Contractor:  TIANCHEN CORP. CHINA	Project :	MKP Methanol Project			Owner :  شرکت کیمیای پارس خاورمیانه Middle East Kumiya Pars Co.
	Unit	General Technical	Phase	Detail Engineering	
	Doc. Title :	PACKAGE HAZOP			
Vendor :  新鼎信息技術(上海)有限公司 Advanced Control & Information Technologies Co., Ltd.	Owner No.	MKP-11-DE-9000-SF-RPT-001B			Rev. : 0
	Contr. No.:	MKP-11-DE-9000-SA01-RPT-001B			
	Vendor No.	16E2416A			Page : 1 of 25

PACKAGE HAZOP

Node 7201

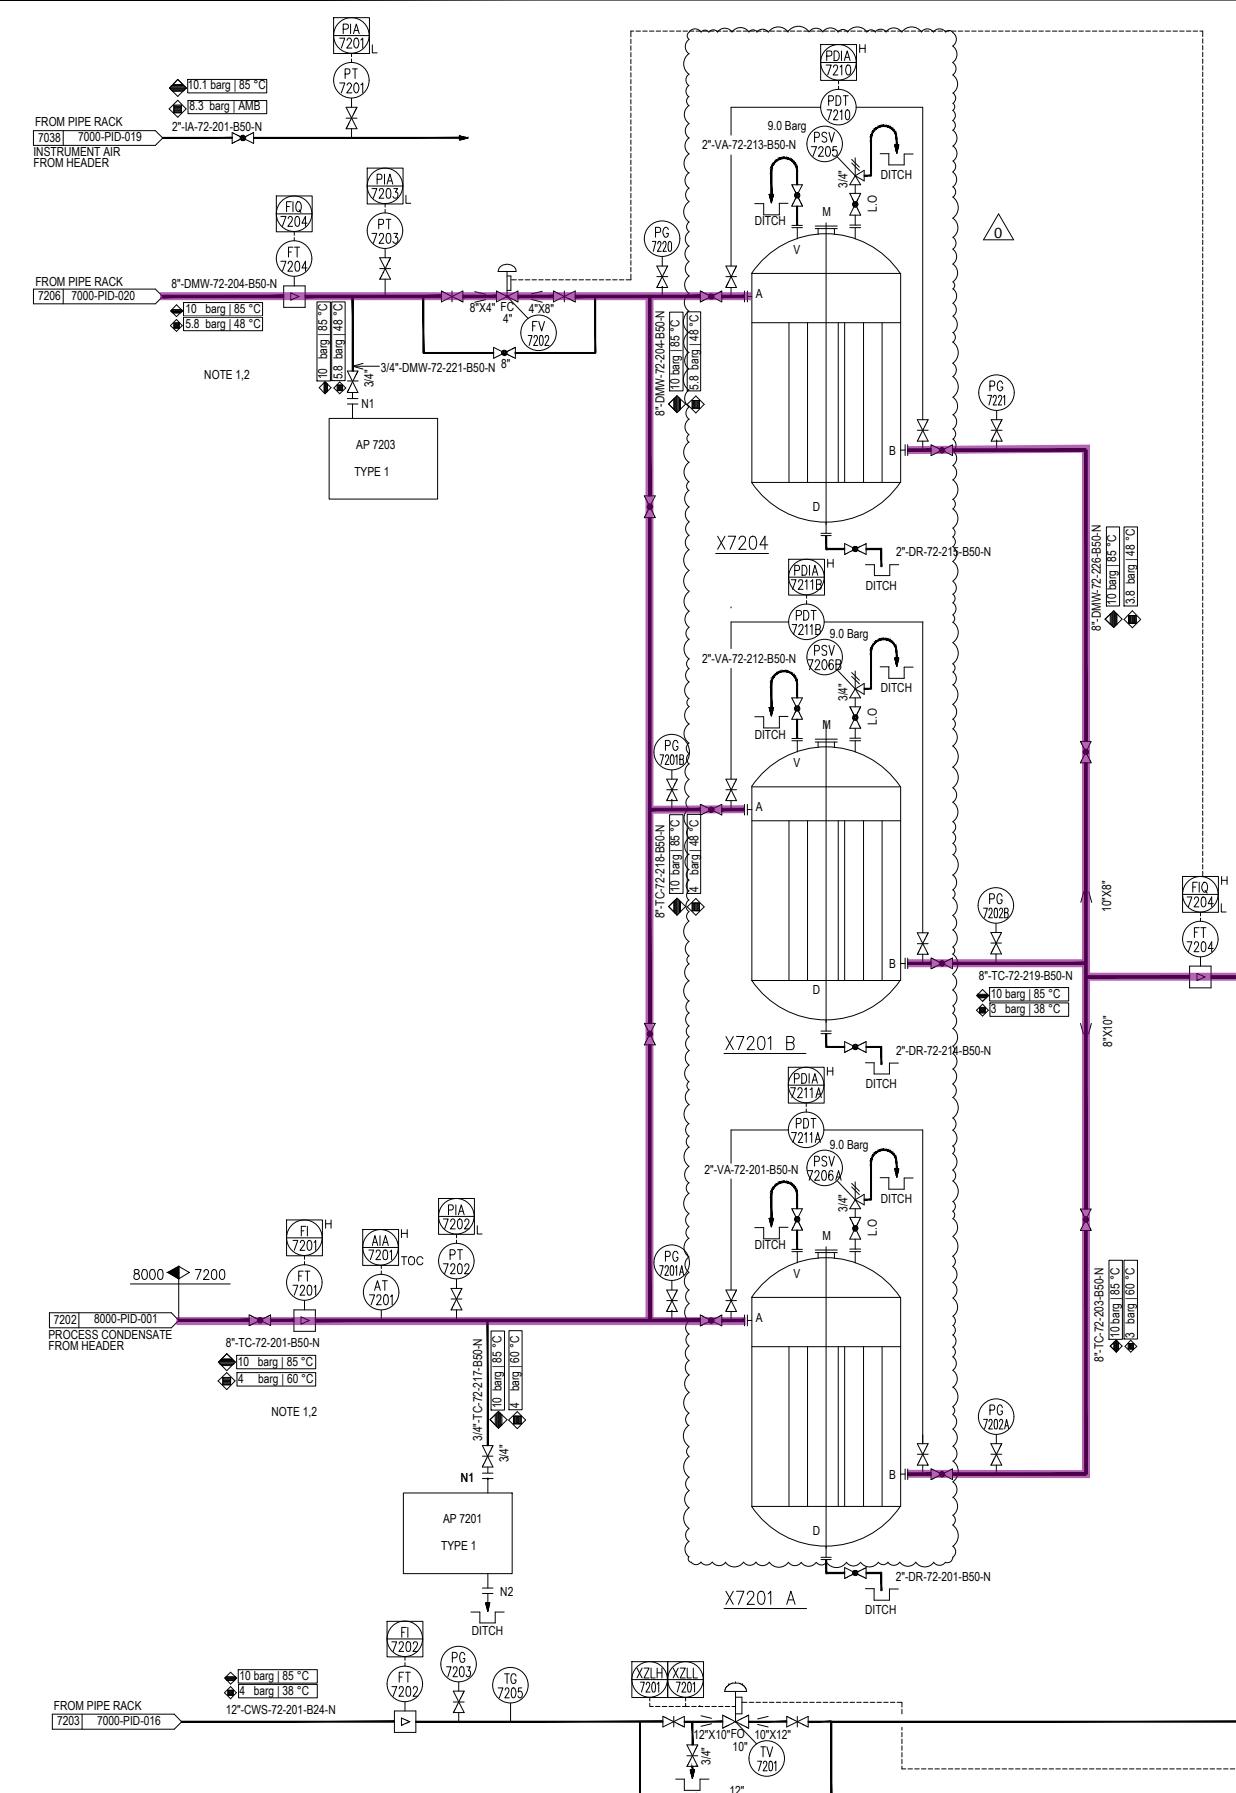
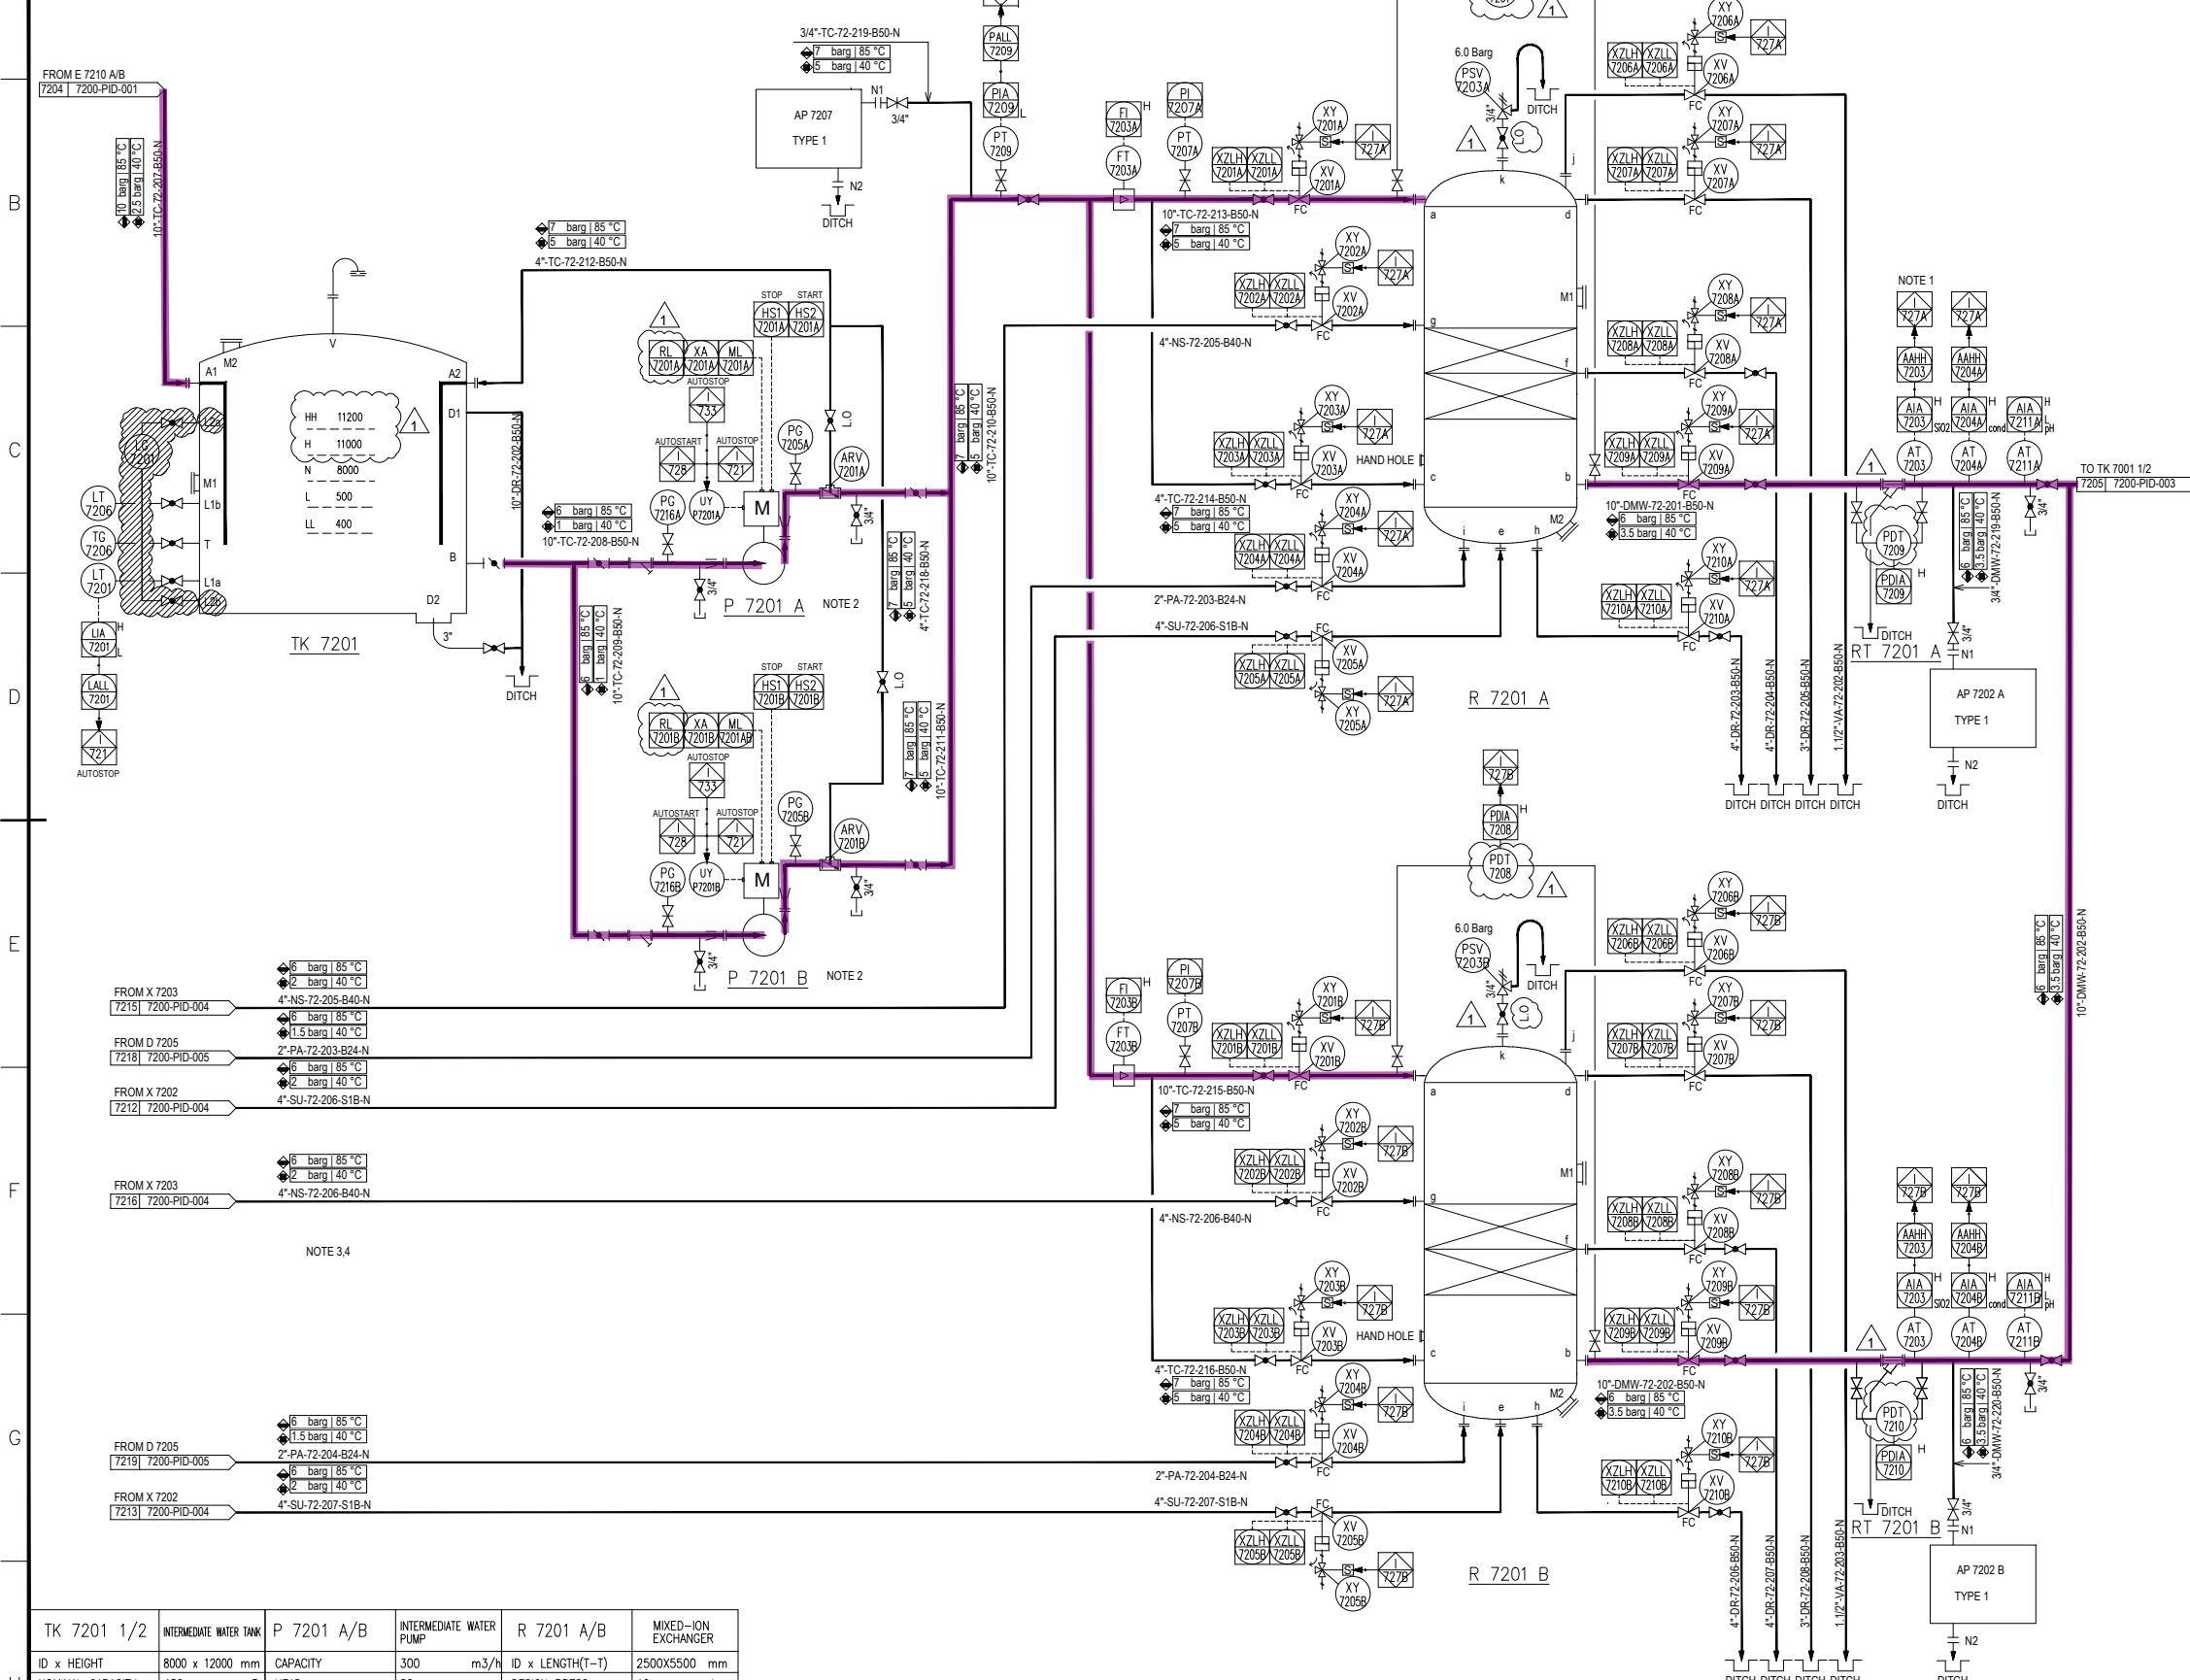
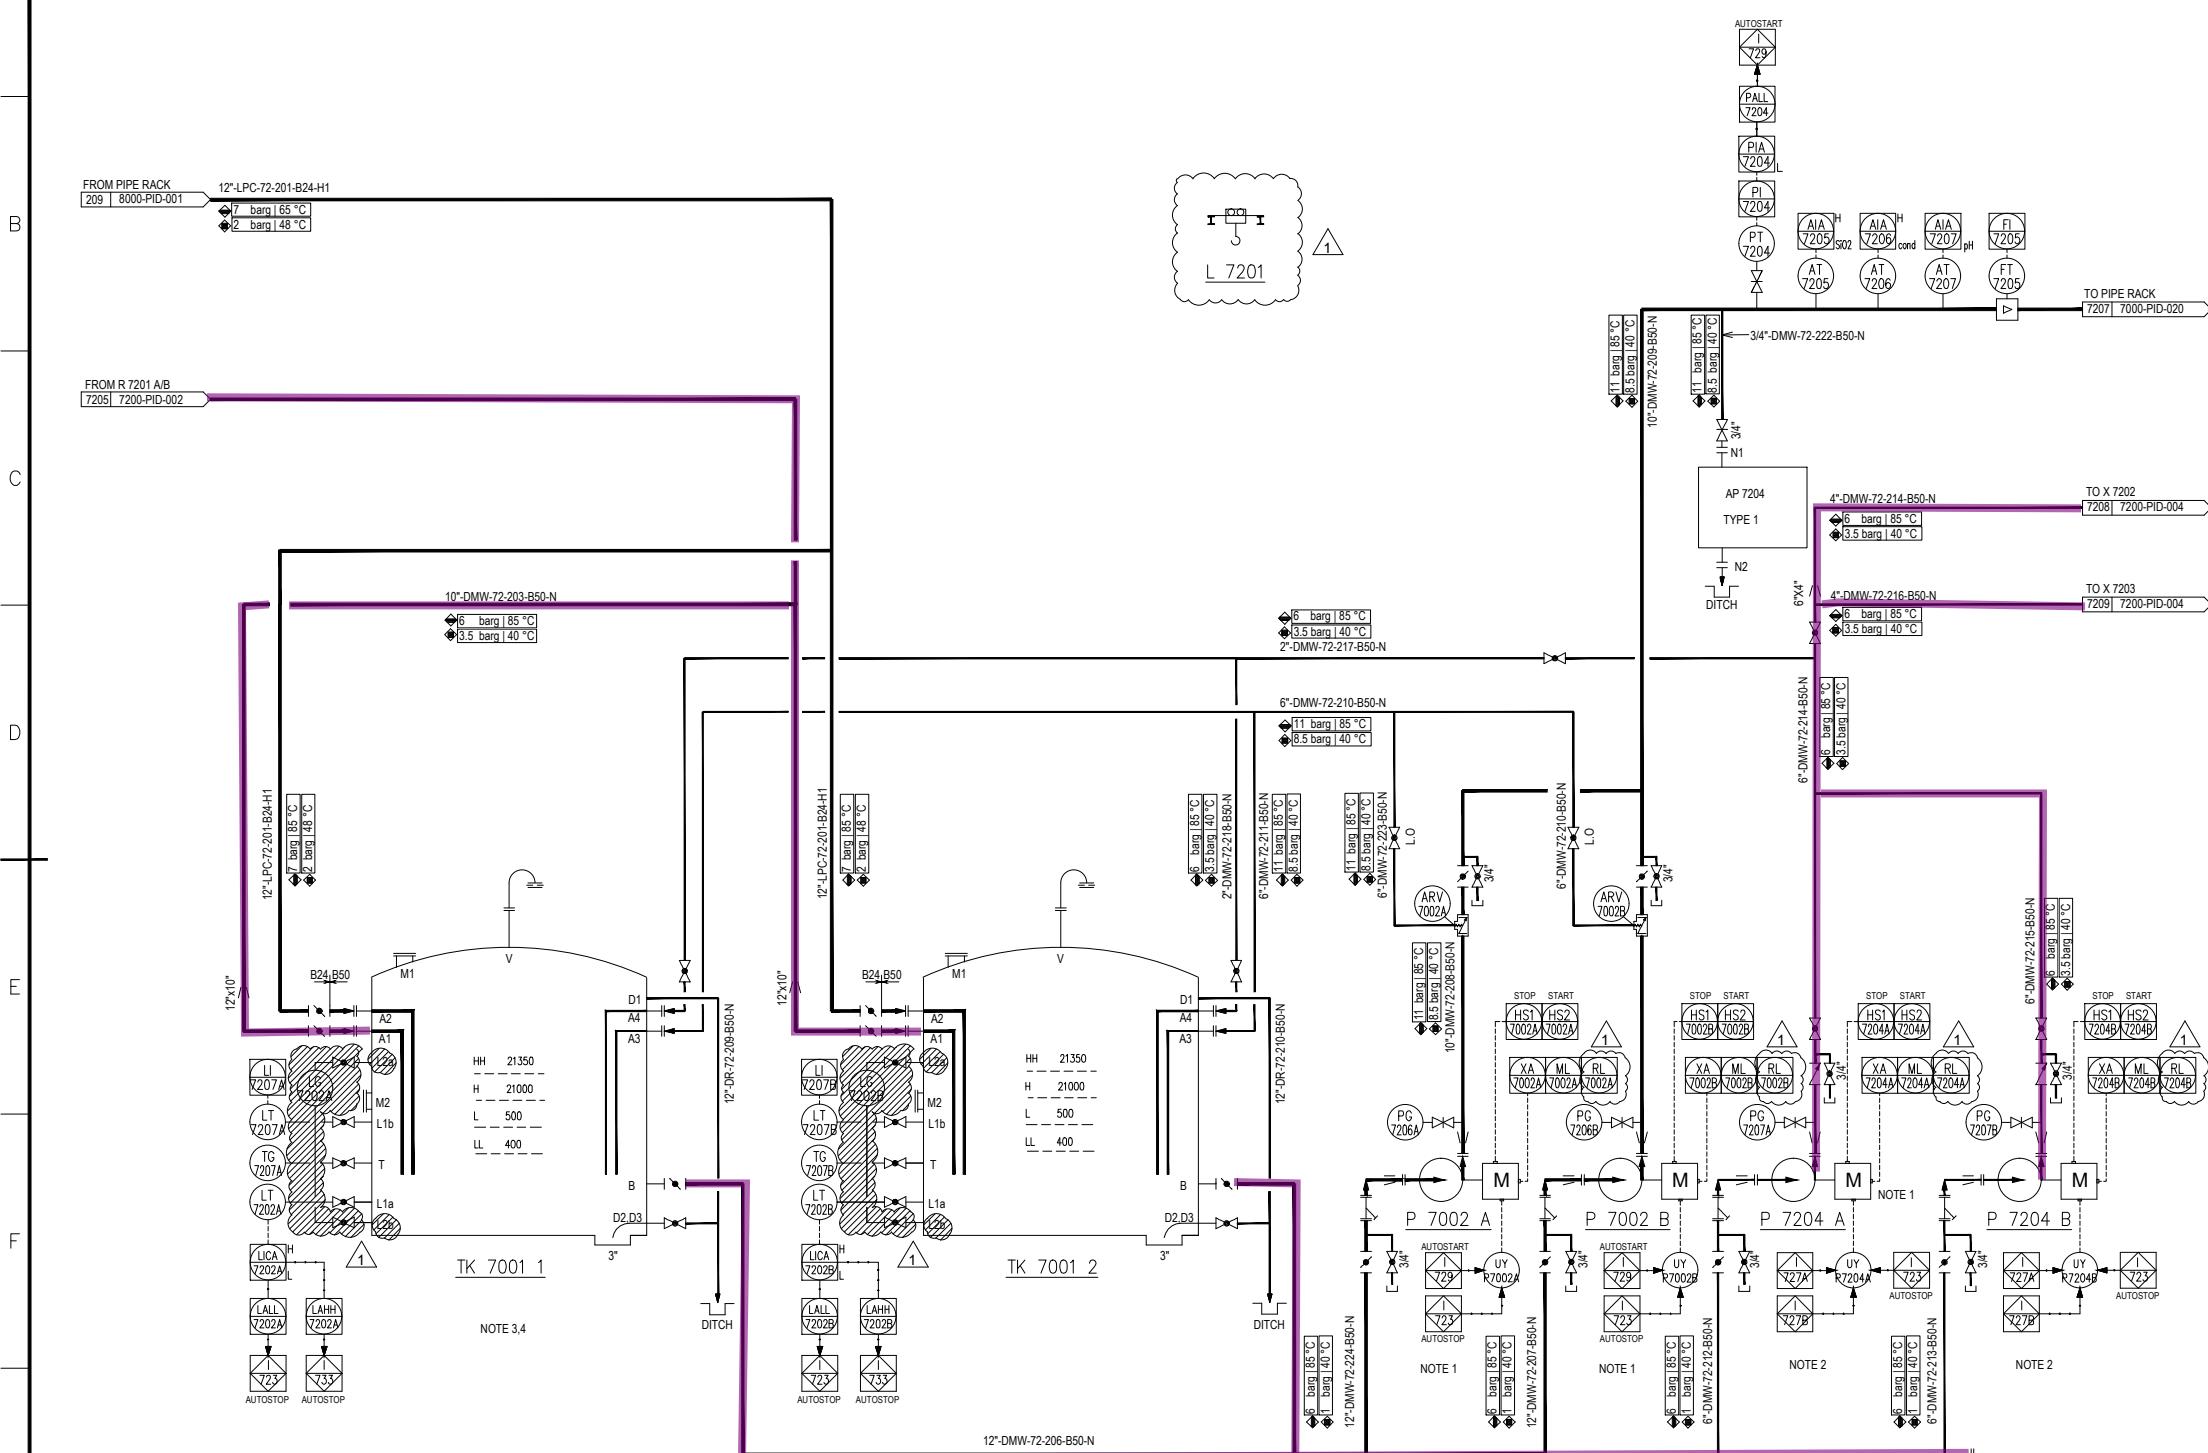
7201.9	2	1.Add check valve on 8"-DMW-70-108-B50-N of 7000-PID-020.	Y			TCC
7201.10	2	1.Add check valve on 8"-TC-72-201-B50-N. 2.P-3011A/B should be considered as auto start(should be confirmed with GE).	Y			TCC
7201.11	3	Supply chemical from well known vendor, with high quality and test before use in plant.	Y			TCC
7201.12	2	1.Add alarm high for PT-7202. 2. Correct setpoint of PSV-7205 and PSV-7206A/B to 10 barg.	Y			TCC
7201.13	2	1.Add alarm high for PT-7203. 2.Correct setpoint of PSV-7205 and PSV-7206A/B to 10 barg.	Y			TCC
7201.14	3	1.Add alarm high for PT-7207A/B. 2. Correct setpoint of PSV-7203A/B to 7 barg.	Y			TCC
7201.15	1	1.Correct design pressure of discharge line from P-7002A/B to 14 barg.	Y			TCC
7201.23	2	1.Add high alarm for AT/AI-7208. 2.Add high alarm for AT/AI-7209.	Y			TCC

. 8	low flow (R-7201A/B inlet)	1 1.P-7201A/B failure. 2. Manual valve abnormally close.	1.TK-7001 1/2 low level.	1.LT-7202A/B low level alarm. 2.FT-7203A/B indicator. 3.Auto start P-7201A/B by PT-7209.	2	4	2	N	1.Add low alarm for FT-7203A/B.

. 12	high pressure(condensate)	1 1.X-7201A/B,X-7204 blockage. 2.Human error in operating both P-3011A/B at the same time.	1.Overpressure damage equipment and pipe.	1.PT-7202 indicator. 2.PSV-7206A/B and PSV-7205 @9bar.	3	3	2	N	1.Add alarm high for PT-7202. 2. Correct setpoint of PSV-7205 and PSV-7206A/B to 10 barg.
. 13	high pressure(DMW)	1 1.X-7201A/B,X-7204 blockage. 2.High pressure in upstream.	1.Overpressure damage equipment and pipe. 2.Back pressure to P-3011A/B.	1.PT-7203 indicator. 2.PSV-7206A/B and PSV-7205 @9bar. 3.Check valve on discharge of P-3011A/B.	3	3	2	N	1.Add alarm high for PT-7203. 2.Correct setpoint of PSV-7205 and PSV-7206A/B to 10 barg.
